# Access Compliance Report

## Public Rights-of-Way

Intersection ID: 44000	Main Street: ELROSE_PL	Cross Street: GANDER_DR	Location: NW
ADA ID: 8A4A44AC50D0	Ramp Type: Perp	Initial Pass/Fail: Fail	Overall Compliance: No
Codes/Mitigation Info/Possible Solution		Field Measurements/Component Compliance

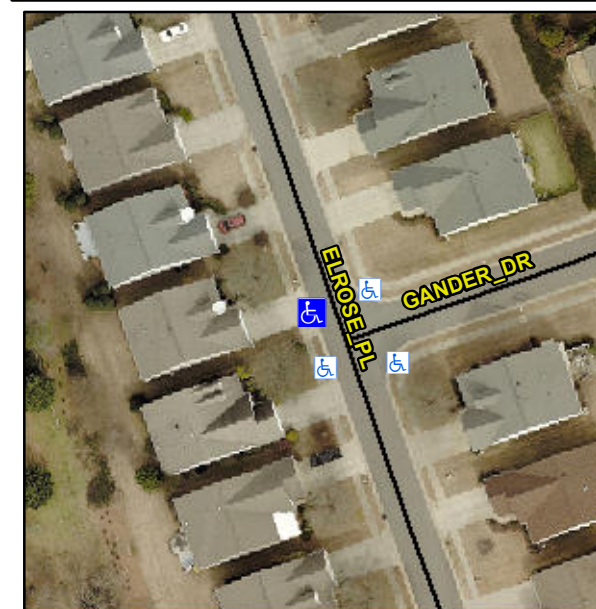
**Not Found, R304.2.2, R304.5.3**

Compliance	Description	Data	Compliance	Description	Data
N/A	Ramp Length (in)	48.0	No	Ramp Slope (%)	11.1
Yes	Ramp Width (in)	48.0	No	Ramp XSlope (%)	5.3
N/A	Flare Type LT	N/A	N/A	Flare Type RT	N/A
N/A	Flare Slope LT (%)	N/A	N/A	Flare Slope RT (%)	N/A
N/A	Flare Traversable LT?	N/A	N/A	Flare Traversable RT?	N/A
N/A	Landing Length (in)	N/A	N/A	DWS Provided?	N/A
N/A	Landing Width (in)	N/A	N/A	DWS Contrast?	N/A
N/A	Landing Slope (%)	N/A	N/A	DWS Length (in)	N/A
N/A	Landing X Slope (%)	N/A	N/A	DWS Full Width?	N/A
N/A	Landing Curb? (Y/N)	N/A	N/A	DWS Offset (in)	N/A
N/A	Shared Landing?	N/A			
N/A	Gutter Ponding?	N/A	N/A	Gutter Slope (%)	N/A
N/A	Gutter Lip Ht (in)	N/A	N/A	Gutter X Slope (%)	N/A
N/A	Painted X Walk1?	No	N/A	Painted X Walk2?	N/A
	X Walk 1 Direction	To E		X Walk 2 Direction	N/A
N/A	X Walk 1 Width (in)	N/A	N/A	X Walk 2 Width (in)	N/A
	X Walk 1 Slope (%)	4.0		X Walk 2 Slope (%)	N/A
	X Walk 1 X Slope (%)	2.6		X Walk 2 X Slope (%)	N/A

**Remove & Replace Entire Ramp.**
